# Access Compliance Report

## Public Rights-of-Way

### (Curb Ramps)

Intersection ID: 10074	Main Street: KILDARE_DR	Cross Street: OLINDA_ST	Location: W
ADA ID: F263B0AC1C9F	Ramp Type: Perp	Initial Pass/Fail: Fail	Overall Compliance: No
Severity Score: 12.5			
Codes/Mitigation Info/Possible Solution		Field Measurements/Component Compliance

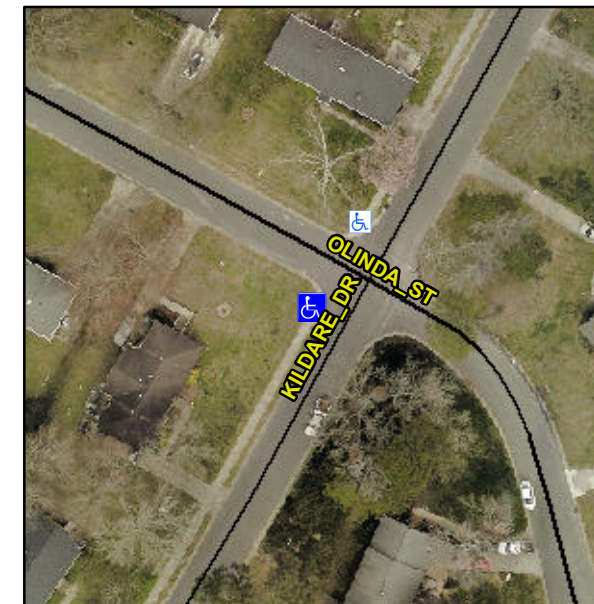
**Not Found, R304.5.3**

Compliance	Description	Data	Compliance	Description	Data
N/A	Ramp Length (in)	94.0	Yes	Ramp Slope (%)	6.6
Yes	Ramp Width (in)	60.0	No	Ramp XSlope (%)	5.2
N/A	Flare Type LT	N/A	N/A	Flare Type RT	N/A
N/A	Flare Slope LT (%)	N/A	N/A	Flare Slope RT (%)	N/A
N/A	Flare Traversable LT?	N/A	N/A	Flare Traversable RT?	N/A
N/A	Landing Length (in)	N/A	N/A	DWS Provided?	N/A
N/A	Landing Width (in)	N/A	N/A	DWS Contrast?	N/A
N/A	Landing Slope (%)	N/A	N/A	DWS Length (in)	N/A
N/A	Landing X Slope (%)	N/A	N/A	DWS Full Width?	N/A
N/A	Landing Curb? (Y/N)	N/A	N/A	DWS Offset (in)	N/A
N/A	Shared Landing?	N/A			
N/A	Gutter Ponding?	N/A	N/A	Gutter Slope (%)	N/A
N/A	Gutter Lip Ht (in)	0.8	N/A	Gutter X Slope (%)	N/A
N/A	Painted X Walk1?	No	N/A	Painted X Walk2?	N/A
	X Walk 1 Direction	To NE		X Walk 2 Direction	N/A
N/A	X Walk 1 Width (in)	N/A	N/A	X Walk 2 Width (in)	N/A
	X Walk 1 Slope (%)	3.1		X Walk 2 Slope (%)	N/A
	X Walk 1 X Slope (%)	3.6		X Walk 2 X Slope (%)	N/A

**Remove & Replace Entire Ramp.**
